Application No.: 02119994.9	Department:	Date of Dispatch July 30, 2004
Applicant: CITIZEN ELECTRONICS CO., LTD.		
Title: CONDENSER MICROPHONE AND METHOD FOR MANUFACTURING CONDENSER MICROPHONES

**THE OFFICE ACTION**

## The Text of the Second Office Action

图 10

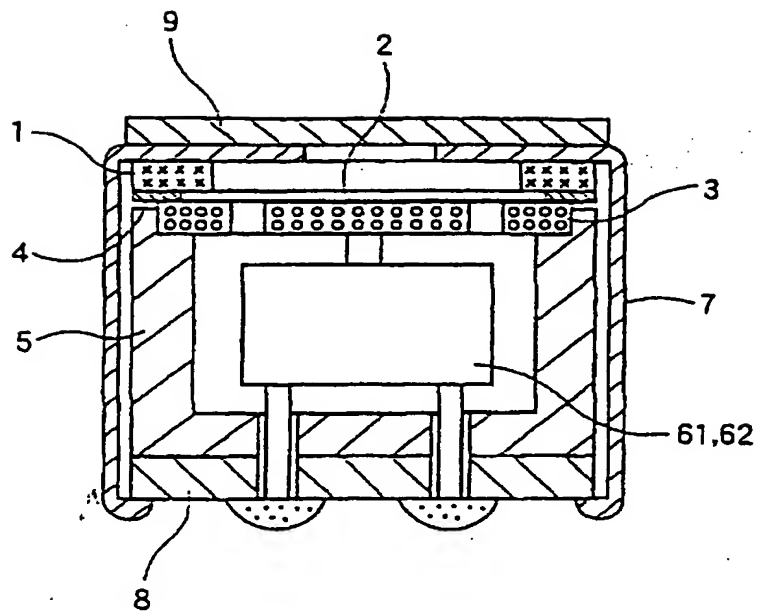
Claim 1 requests to claim a condenser microphone. Reference document 1 (CN1290998A) has disclosed a semiconductor electret condenser microphone widely used as digital portable telephones (corresponding to the condenser microphone of claim 1) and the following technical features (See lines 3 to 11 of page 1 of the specification and Figure 10): comprising a printed circuit board 8 (corresponding to the substrate of claim 1), a back electrode holder 5 for holding a back electrode 3 and fixed on the printed circuit board, a spacer 4 provided on the back electrode, a diaphragm 2 provided on the spacer, and a ring 1 having a sound exporting hole and adhered to the diaphragm.

It can be seen that the technical solution of claim 1 is different from that of D1 in that claim 1 further defines the back plate secured to the substrate with adhesive, the spacer adhesively secured between the back plate and the diaphragm electrode. However, although D1 does not definitely limit whether the adhesive is used between the back electrode holder 5 and the printed circuit board 8, between the spacer 4, the back electrode 3 and the ring 1, in order to obtain a securely strong connection between these members it is common technical means for the person skilled in the present field to use an adhesive to secure them, and there has been the adhesive between the ring 1 and the diaphragm 2 in D1, thereby it is very easy and can be conceived to apply adhesive between other members. Therefore, claim 1 does not have prominent substantive features nor represents notable progress over D1, not conforming to the provision of Item 3 of Article 22 of the Chinese Patent Law.

2. The additional technical features of claim 2 have been disclosed in D1 (See lines 3 to 12 of page 1 of the specification, Figure 10). In D1,

a recess in which wirings connecting the back electrode, the diaphragm and the printed circuit board is also provided on a side of the microphone. Therefore, claim 2 does not have inventiveness over D1, not conforming to the provision of Item 3 of Article 22 of the Chinese Patent Law.
